SUBJECT: SEABROOK STATION, UNIT NO. 1 - ISSUANCE OF AMENDMENT  
REGARDING LICENSE AMENDMENT REQUEST 14-04, REVISED REACTOR  
COOLANT SYSTEM PRESSURE/TEMPERATURE LIMITS APPLICABLE FOR  
55 EFFECTIVE FULL POWER YEARS (TAC NO. MF4577)

Amendment No. 151  
License No. NPF-86

SAFETY EVALUATION BY THE OFFICE OF NUCLEAR REACTOR REGULATION

RELATED TO AMENDMENT NO. 151

**FIGURE 3.4-2**  
**REACTOR COOLANT SYSTEM HEATUP LIMITATIONS – APPLICABLE UP TO 55 EFPY**

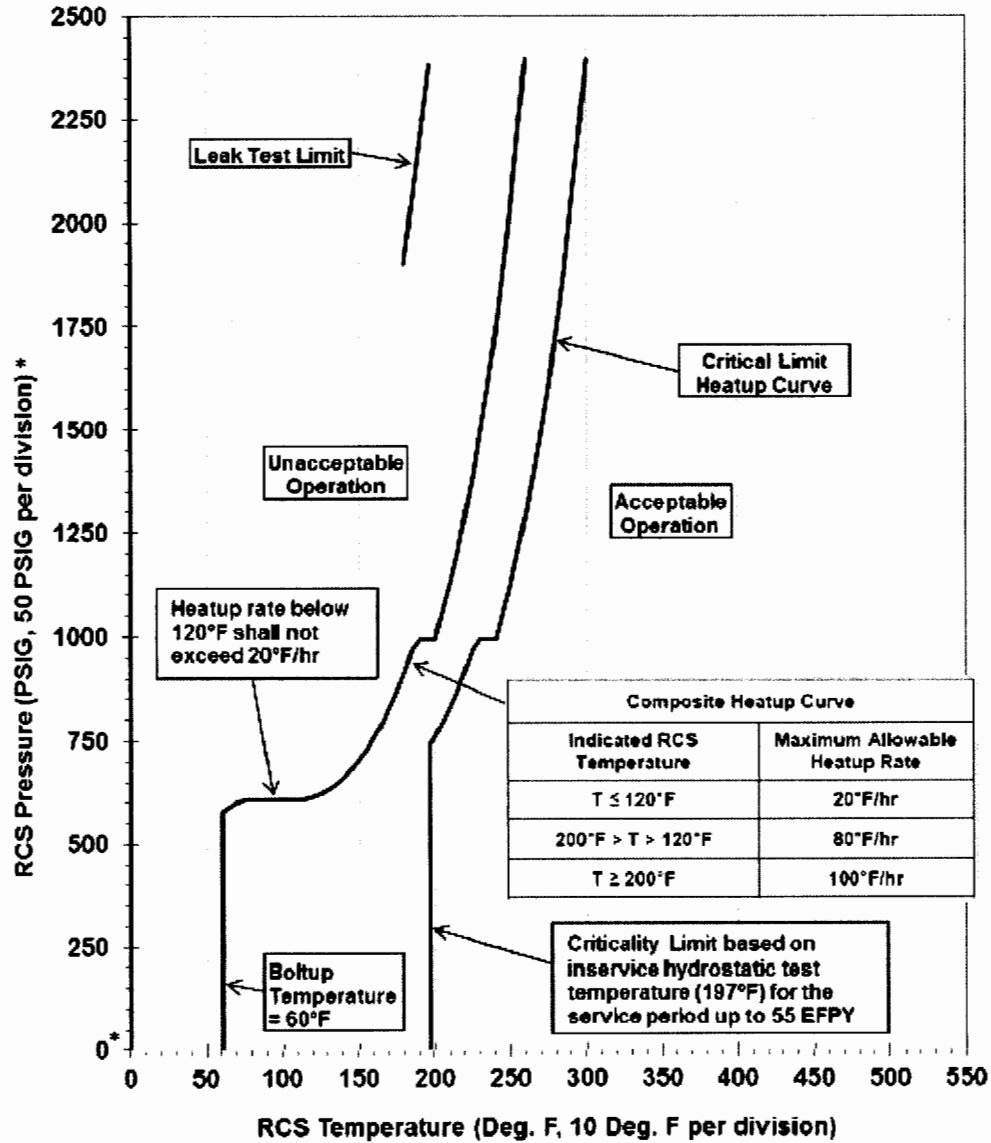
- Replace current Figure 3.4-2, "Reactor Coolant System Heatup Limitations - Applicable Up to 23.7 EFPY," with a new figure applicable to 55 EFPY.
- Replace Figure 3.4-3, "Reactor Coolant System Cooldown Limitations - Applicable Up to 23.7 EFPY," with a new figure applicable to 55 EFPY.

In addition to the incorporation of instrument uncertainties, the revised P-T limit curves submitted in the RAI response dated July 9, 2015, also incorporate an additional restriction to the RCS heatup and cooldown rates specified on the curves for lower reactor coolant temperatures. Specifically, for the TS heatup P-T limit curve in proposed TS Figure 3.4-2, the licensee added a restriction to the RCS heatup rate of less than or equal to 20 °F per hour ( $\leq 20$  °F per hour) for reactor coolant temperatures less than 120 °F ( $< 120$  °F). For the TS cooldown P-T limit curve in proposed TS Figure 3.4-3, the licensee added a restriction to the RCS cooldown rate of  $\leq 20$  °F per hour for reactor coolant temperatures  $< 150$  °F. The licensee stated that these changes eliminate the heatup and cooldown rates (greater than 20 °F per hour) that are unachievable for normal RCS operation in these lower temperature ranges.

- (1) The licensee's proposed 55 EFPY TS P-T limit curves in TS Figures 3.4-2 and 3.4-3 meet the criteria of the ASME Code, Section XI, Appendix G, and are in compliance with the fracture toughness requirements of 10 CFR 50.60 and 10 CFR Part 50, Appendix G through 55 EFPY.

FIGURE 3.4-4 MAXIMUM ALLOWABLE PORV SETPOINTS FOR COLD OVERPRESSURE PROTECTION SYSTEM

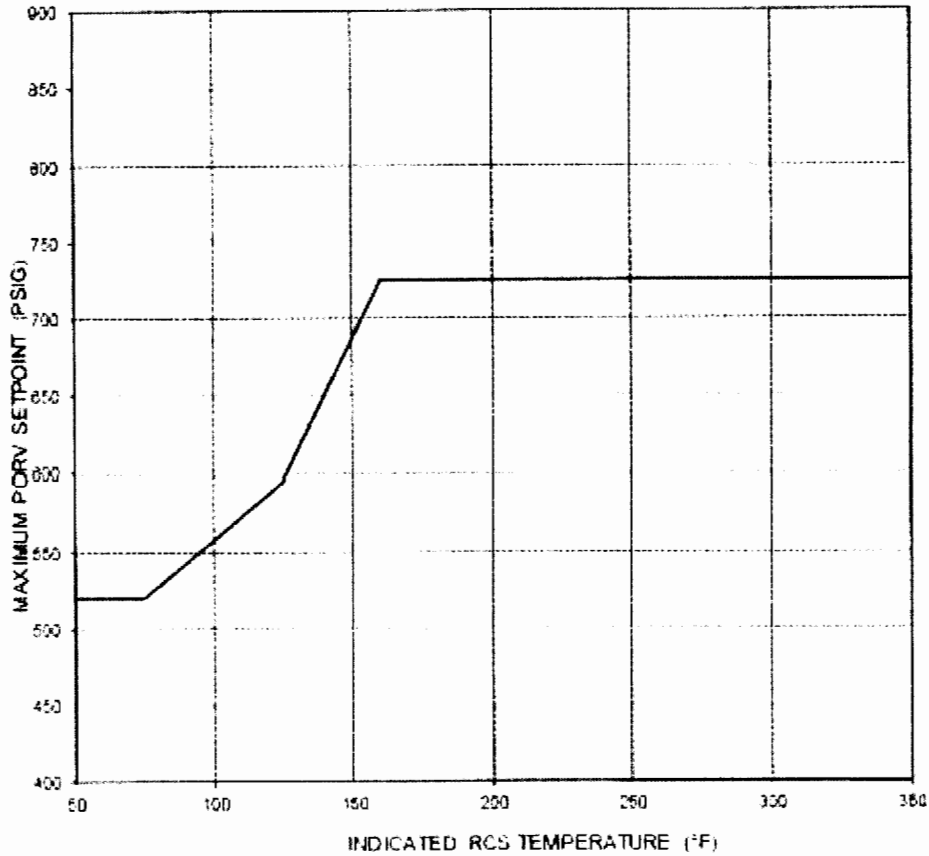
results in higher operating margins for the PORV setpoints. Therefore, based on the proposed P-T limit curve changes, new PORV setpoints were developed by the licensee. As such, the proposed changes include a new TS Figure 3.4-4 applicable up to 55 EFPYs to replace the current TS Figure 3.4-4 (applicable up to 23.7 EFPYs).

- Replace the current Figure 3.4-4, "RCS Cold Overpressure Protection Setpoints," with a new Figure 3.4-4, "Maximum Allowable PORV Setpoints for Cold Overpressure Protection System," which is valid for up to 55 EFPYs.

NextEra discussed the changes to the PORV setpoints in Section 3.2 of the enclosure to the LAR. The NRC staff verified that the revised PORV setpoints were formulated in accordance with the NRC-approved methodology described in Chapter 3 of WCAP-14040-A for LTOP systems (also referred to as "cold overpressure mitigating systems" in WCAP-14040-A). The licensee was able to establish higher operating margins for the PORV setpoints by developing P-T limit curves without the 10 CFR Part 50, Appendix G, Table 1 RPV minimum temperature requirements for the closure flange for RCS pressures  $> 20\%$  of  $P_H$ , as discussed above. Since the licensee developed the setpoints in accordance with an NRC-approved methodology, the NRC staff determined that the proposed changes to these setpoints are acceptable for 55 EFPY.
